**BOARD ACTION REPORT – APPEALABLE ITEM**

**Project Name:** 324 Lofts  
**Project Location:** 324 NE 3<sup>rd</sup> Avenue  
**Request:** Class V Site Plan  
**Board:** Site Plan Review and Appearance Board  
**Meeting Date:** June 28, 2017

### ---STAFF REPORT---

**ITEM:** **324 Lofts (2017-033)** - Class V Site Plan, Landscape Plan, and Architectural Elevations for the new construction of a four-story mixed-use building containing restaurant, yoga studio, professional office, and artist studio uses, with site improvements including two parking spaces, lighting, and landscaping; and, two waiver requests associated with an increase to the front setback from the maximum 15' to 19'4", and a reduction in the required 5' landscape buffer on the property located at **324 NE 3rd Avenue**.

SP1

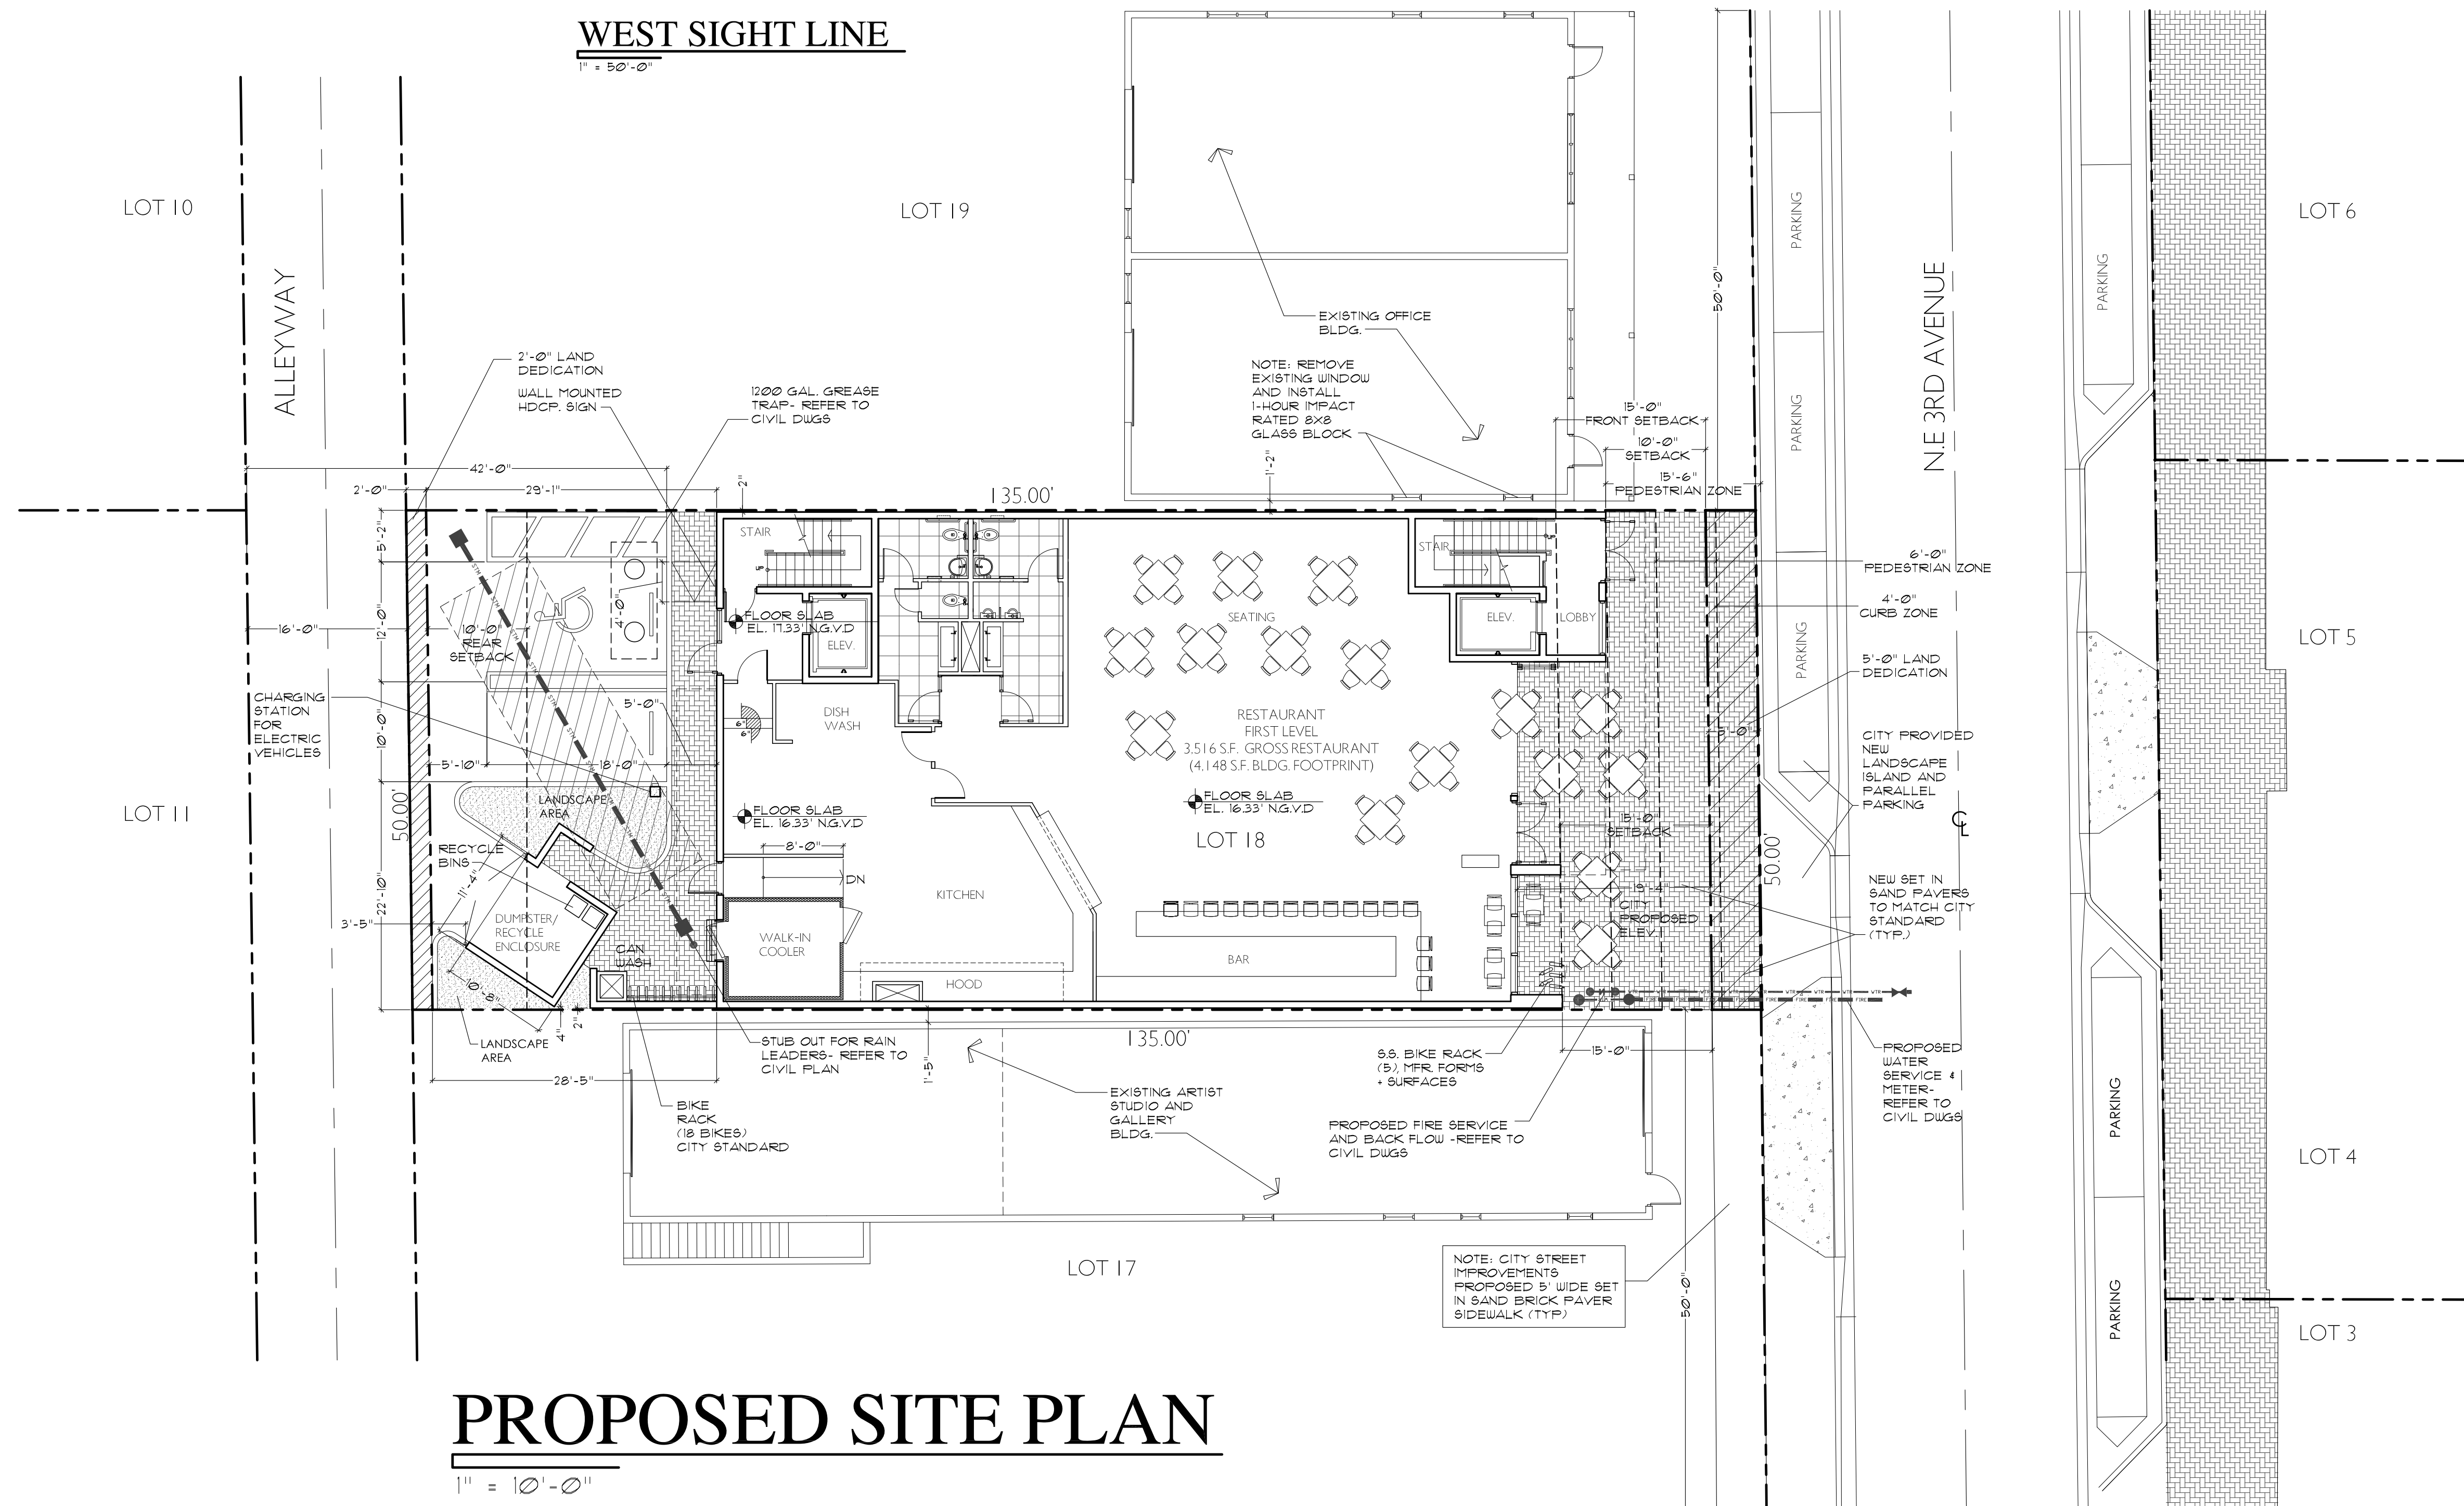
The applicant has requested a waiver to the front setback requirement which requires a maximum setback of 15', whereas the provided front setback is 19'4". This requirement is noted in both LDR Section 4.4.13(E)(4)(e) and Table 4.4.13(C).

The waiver request does not meet the findings or criteria noted above. In consideration of the applicable CBD criteria above, the granting of the waiver is not appropriate as it pushes the front elevation further away from the pedestrian area which is intended to be more active and thereby resulting in an inferior pedestrian experience. The granting of the waiver would allow the creation of significant incompatibilities with new construction along this street once it comes forward. In consideration of the existing buildings, the granting of the waiver may not create an incompatibility as the existing buildings along the street vary in their front setback. The ability to push back the front elevation of the first floor would not result in an erosion of the street or sidewalk network. Last, the waiver would not reduce the quality of the civic open space as this requirement is not applicable to the proposed development.

In consideration of the general waiver criteria, findings cannot be made, as the granting of the waiver would adversely affect the desired design throughout the neighboring area, and the improved pedestrian experience. The provision of public facilities would not be impacted and the creation of an unsafe situation would not occur by the granting of the waiver. However, the granting of the waiver would be considered a special privilege not granted under similar circumstances when developing a vacant property.

Recommend **denial** to the City Commission of the waiver request to **LDR Section 4.4.13(D)(2)(a)1.-2., Configuration of Buildings, Dimensional Requirements for CBD Sub-districts**, to increase the maximum front setback from 15' to 19'4", based on a failure to make positive findings with LDR Sections 4.4.13(K)(8) and 2.4.7(B)(5).

1. That the plans are revised to comply with the maximum front setback of 15';
2. That the required window modifications on the two adjacent buildings are completed prior to the issuance of the building permit for the subject development;
3. That the \$2,000 sidewalk in-lieu fee is paid prior to the issuance of a building permit; and,
4. That the required sidewalk easement and off-site parking agreements are approved by the City Commission and recorded prior to site plan certification.
